**An  
Bord  
Pleanála**

## **FSC Report**

**ABP 309704-21**

Construction of two residential blocks on the same site as the existing Charlestown Development in Finglas, Dublin 11

Figure 2 from JGA CFD Report P1/1376/9 Issue 2

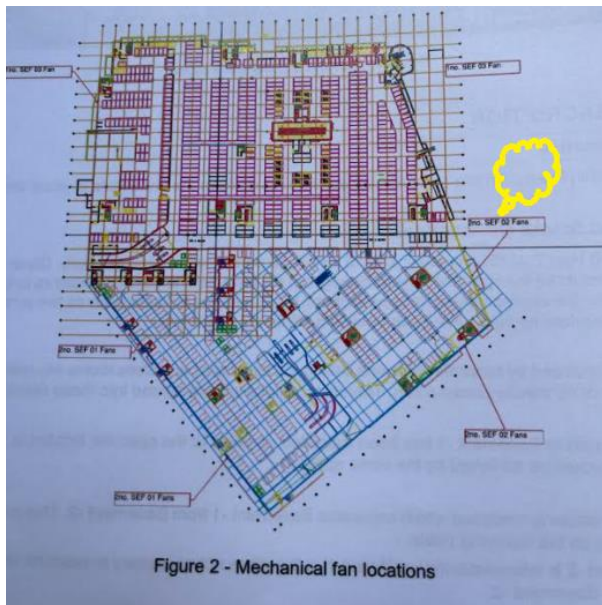
Furthermore it is noted that JGA indicate the presence of 2 x SEF 02 serving Level -1 in Figure 2 of their report which are not shown on the corresponding M&E drawing which they include with their appeal – refer copy extracts below.

- d. There is an anomaly between the Smoke Extract Fans (i.e. 2 x SEF 02) shown in the CFD report and on the VMRA drawings as noted in 2.1 above – which suggest that more fans may have been used in the CFD analysis than is provided for in the VMRA services drawings
